**RE: SEMI-ANNUAL INSPECTION – SPRING, 2026
RURAL IOWA SLF
IDNR PERMIT #42-SDP-1-72P
VERTICAL EXPANSION AREA - CLOSED
HORIZONTAL EXPANSION AREA - ACTIVE
HLW PN 6006-26A.750**

SPRING 2026 INSPECTION

RURAL IOWA SANITARY LANDFILL
ELDORA, IOWA

FIGURE: 1

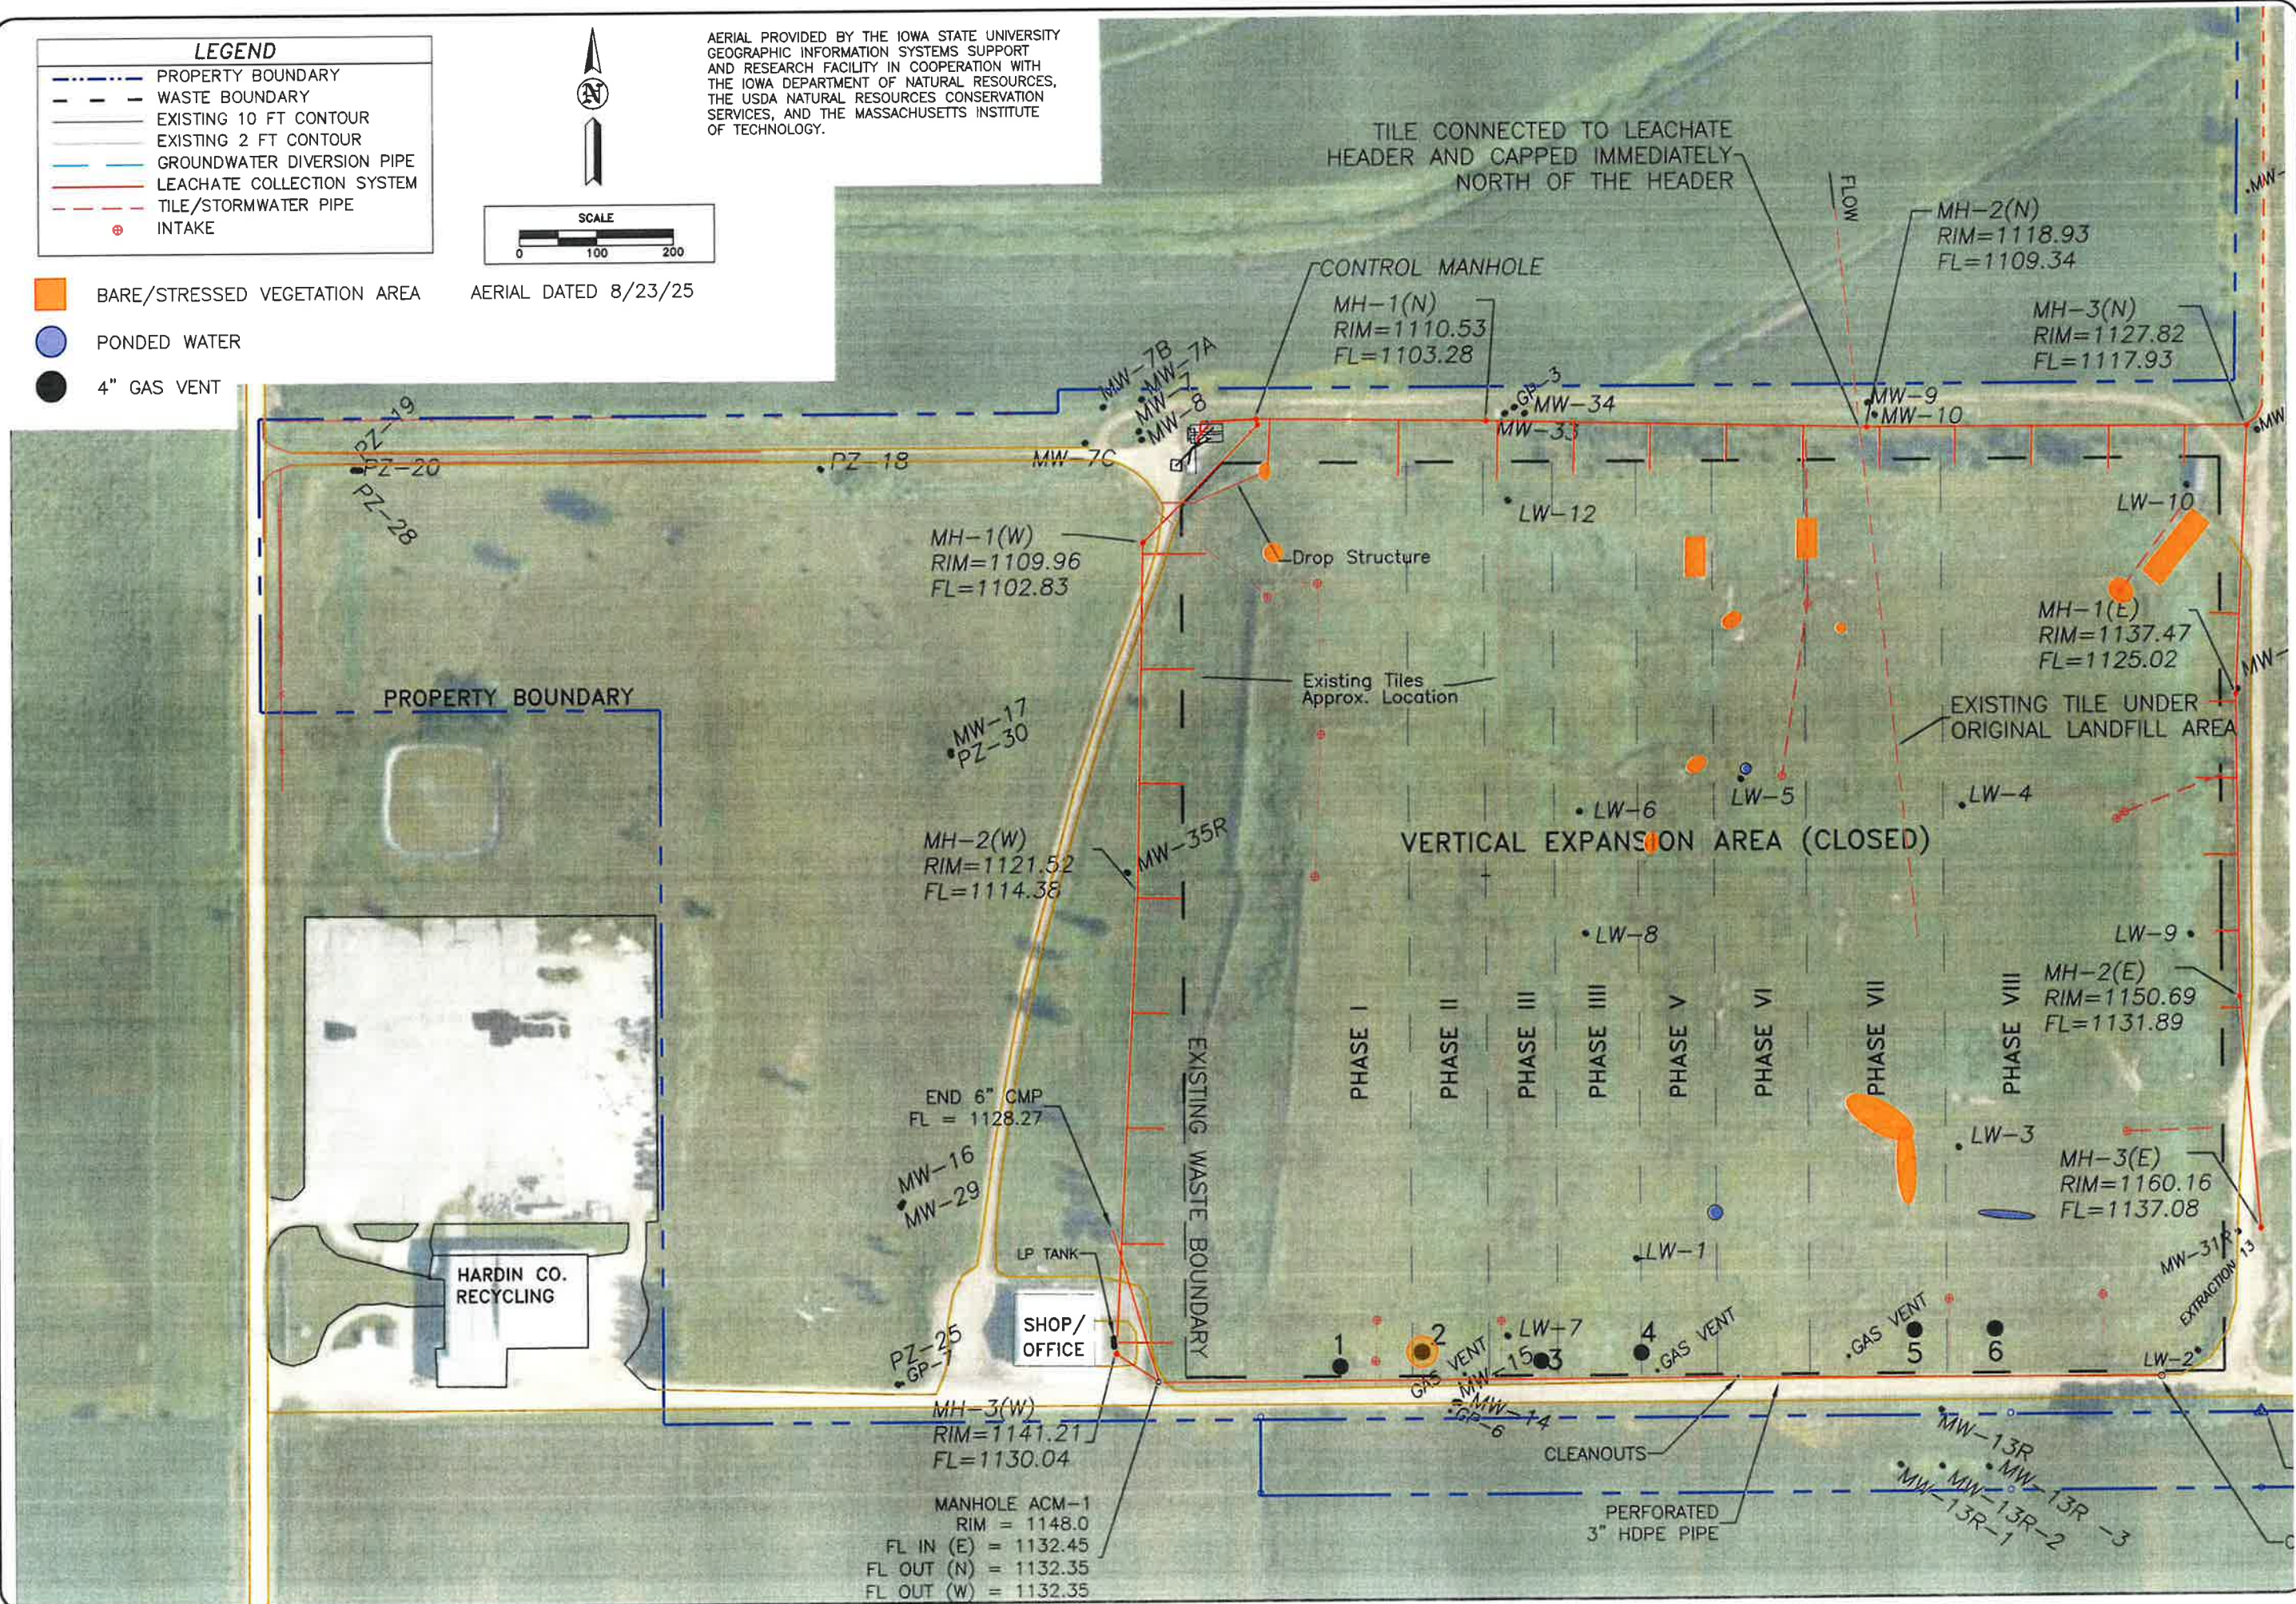
Vegetation is established on the majority of the Original Landfilling Area; however, there are numerous areas on the cap where sparse vegetation/bare spots were noted. The approximate locations of the most significant stressed areas are shown on the attached figure.

Several areas of ponded water were noted in the closed area. The approximate locations of the ponded areas are shown on the attached figure.
